**PLANNING COMMISSION REPORT**  
**Regular Agenda -Public Hearing Item**

**ITEM NO. 5B: PRELIMINARY DEVELOPMENT PLAN FOR ALVAMAR; 1800, 1809, 2021 CROSSGATE DR (SLD)**

**PDP-16-00052:** Consider a Revised Preliminary Development Plan for Alvamar PD, Lots 1, 2a, 2b, and 3, located at 1800, 1809, & 2021 Crossgate Dr. Submitted by Paul Werner Architects, for Eagle 1968, LC, (contract purchaser). Alvamar Inc. is the property owner of record.

**ALVAMAR LOT 1, 2A, 2B & 3**  
**PRELIMINARY**  
**DEVELOPMENT PLAN**

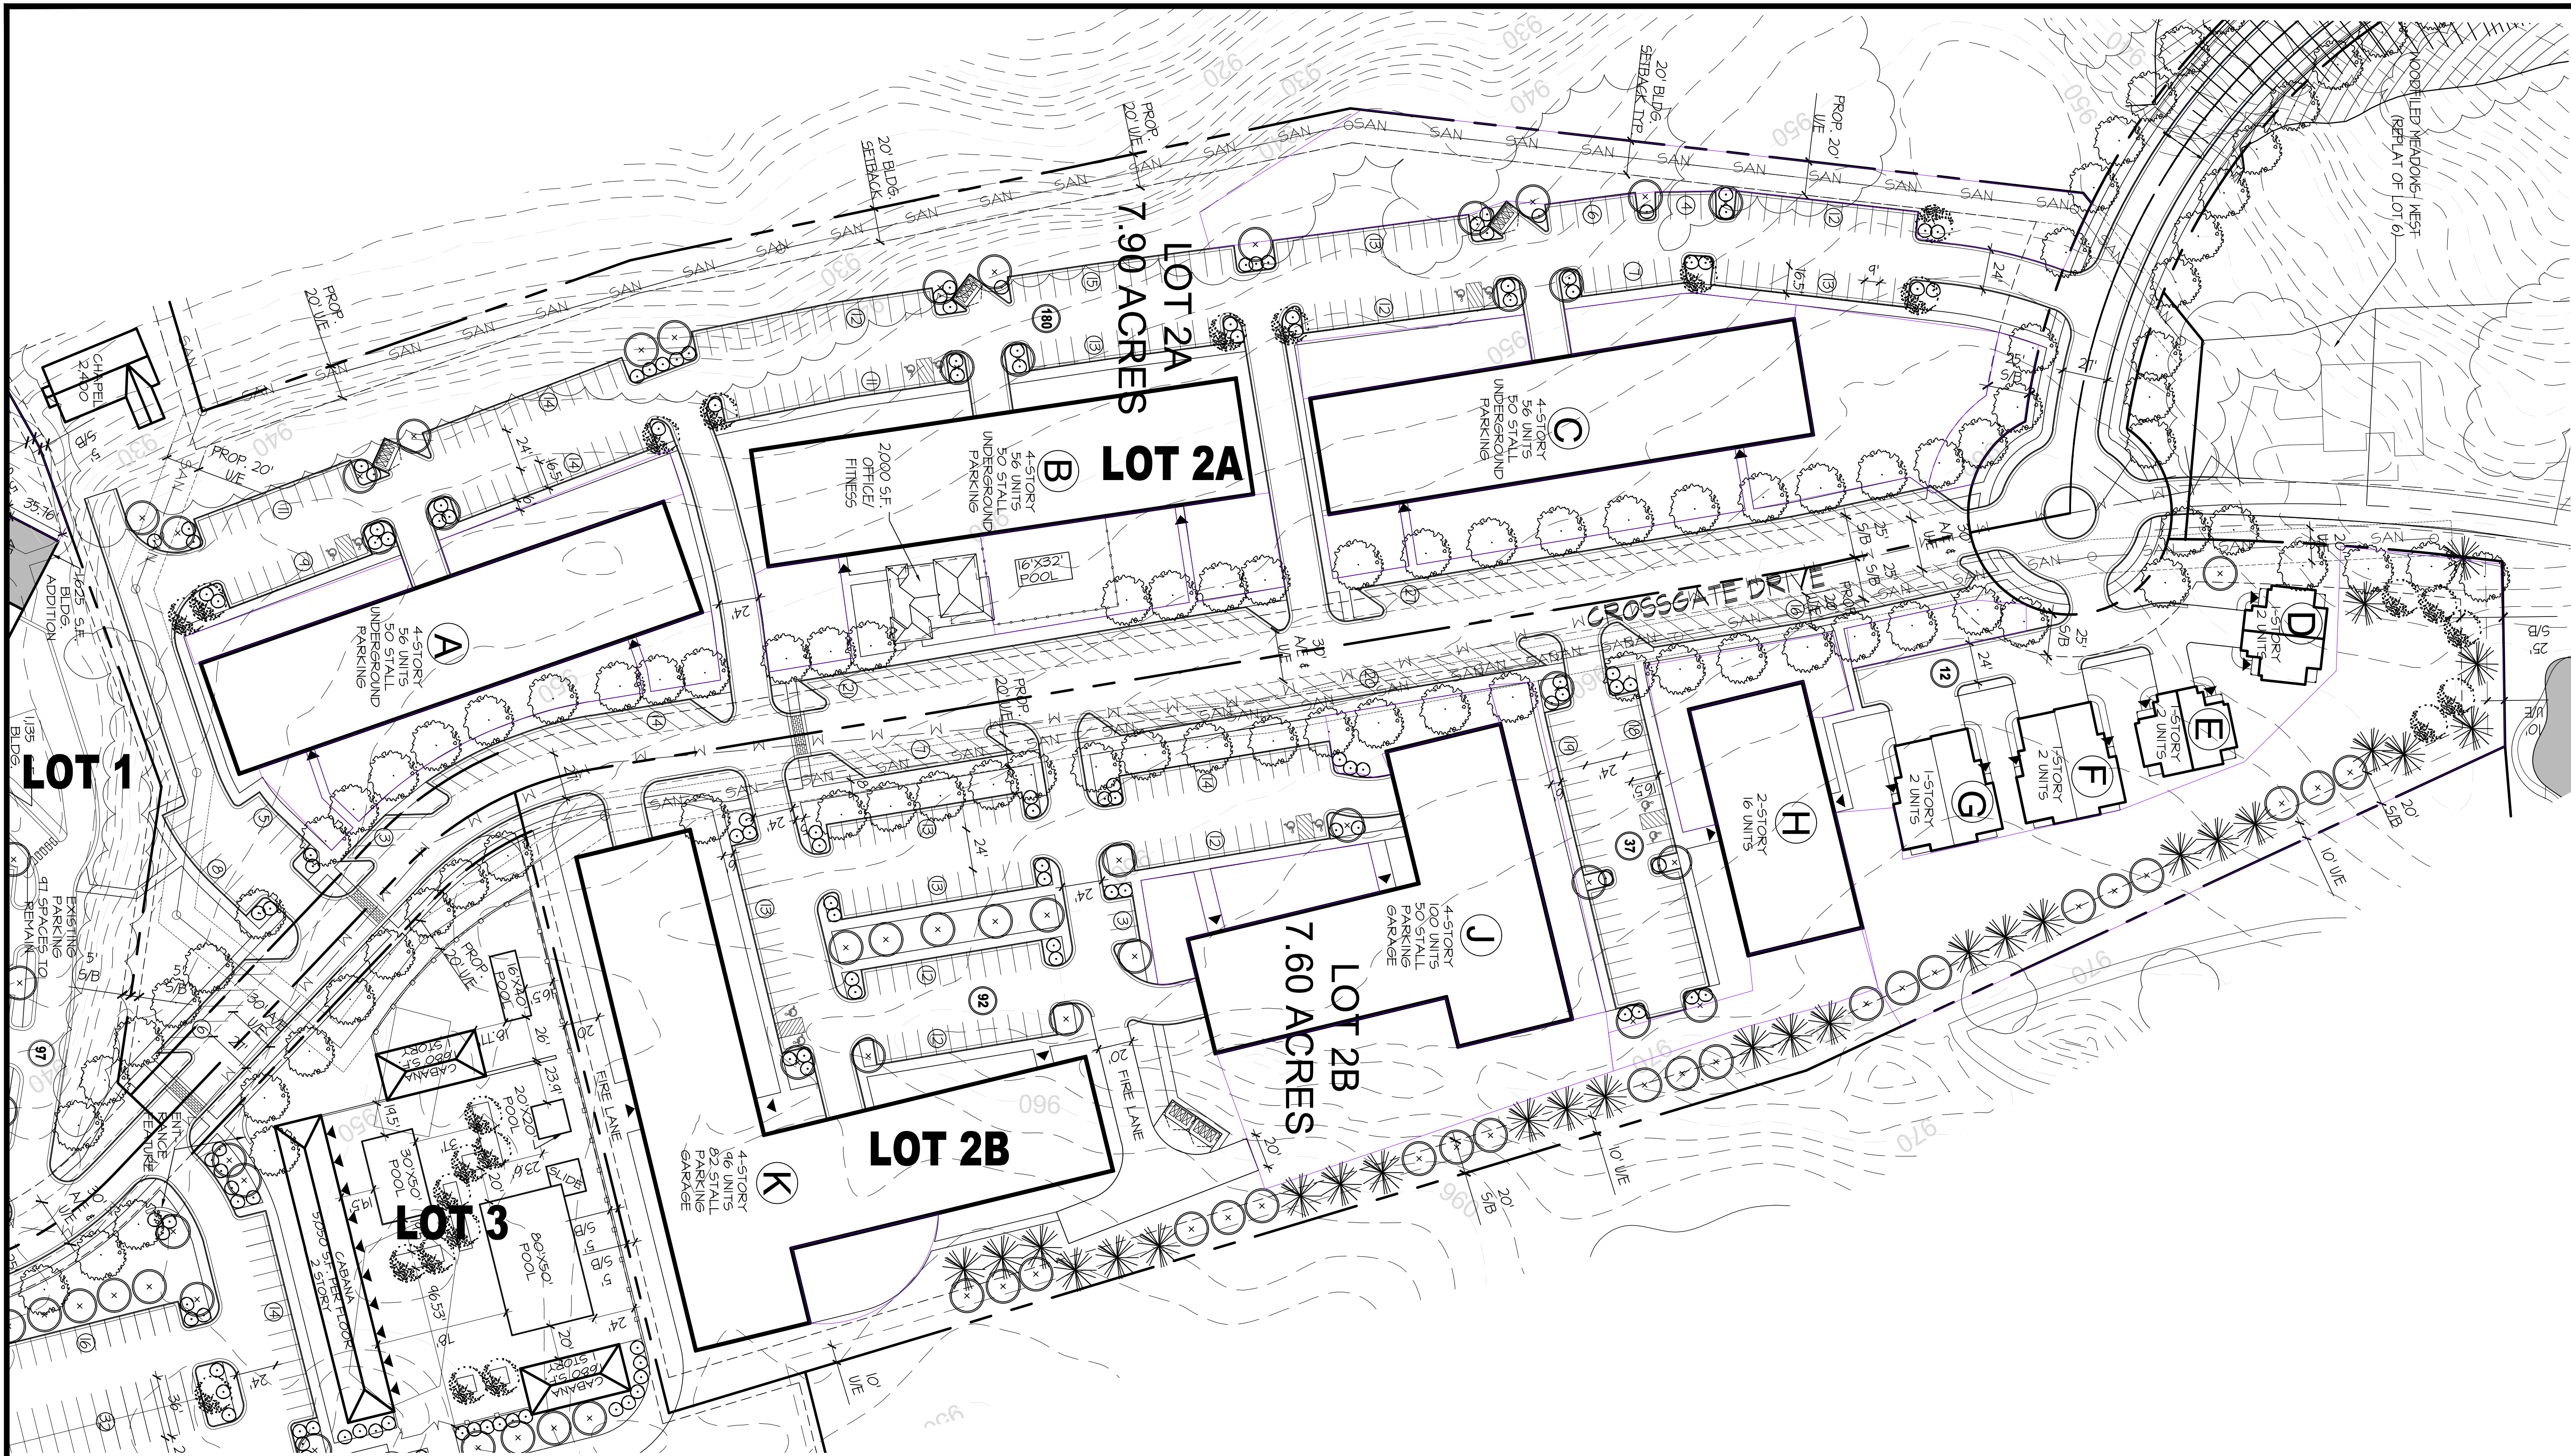
- a. Revise the width of the 30' access/utility easement for the "private street segment" to include sidewalks on both sides of the private street.
  - b. Revise drawing to remove all references to "Sports Medicine".

- c. Revise drawing to provide parking for the chapel use.
  - d. Revise parking table to show the required parking for the Banquet Facility based on the standard for *Event Center, Large* at 1 space per 4 occupancy. This correct parking requirement should show 103 spaces.

- e. Revise the parking table per this staff report to show the total required off-street parking.

- The Event Center requires a total of 103 parking spaces.
- The chapel use requires a total of 25 parking spaces. These spaces were not accounted for by the applicant in the proposed plan.

One additional non-residential use, new to this plan, is also not included in the parking summary. The proposed plan includes a 2,400 SF chapel located on Lot 2A. Parking for *Religious Assembly* is calculated at 1 per 4 seats in the sanctuary or principal worship or assembly space.

The plan shows 114 spaces provided along the private street, however some of these spaces are required to support the residential use. All total, parking for the non-residential uses of this development is short 41 spaces of the Development Code requirements.

**Sidewalks:** Pedestrian connectivity is a key element within this development. Sidewalks are required on both sides of the public and private street network. The plan as proposed shows a 30' Access and Utility Easement that incorporates the private street section. The City Engineer recommends that the easement include the sidewalks. This would increase the easement to approximately 60'. The easement does not impact the lot line or building setback. This easement will also be considered with the Final Plat.
